# 2018 - 2019 Cadillac ATS-V - CTS-V: Service Bulletin: #20-NA-054: Rear View Camera Guidance Lines Dim After Radio Replacement or Programming

## #20-NA-054: Rear View Camera Guidance Lines Dim After Radio Replacement or Programming - (Mar 3, 2020)

**Subject:** Rear View Camera  
Guidance Lines Dim  
After Radio Replacement  
or Programming

**Original design:**

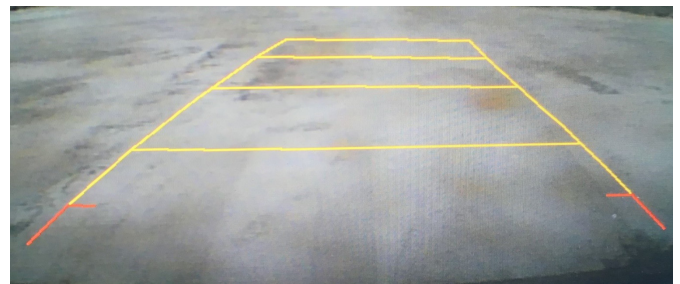
Some customers, after having radio  
replacement or radio reprogramming,  
may report that the Rear-View Camera  
(RVC) guidance lines are not as bold

as previously viewed, that they are faint, see-through, thinner, dim, or translucent; and they used to be more visible. A comparison between similar vehicle models may, or may not, show a difference in rear view camera guidance line appearance.

This may be caused by installing calibration files released in mid-2018 during radio replacement or reprogramming of the radio. The change to increase translucency was done to prevent the lines from

obstructing objects in the field-of-view.

Do not attempt repairs. The thinner, lighter appearance of RVC guidance lines is operating to design intent.
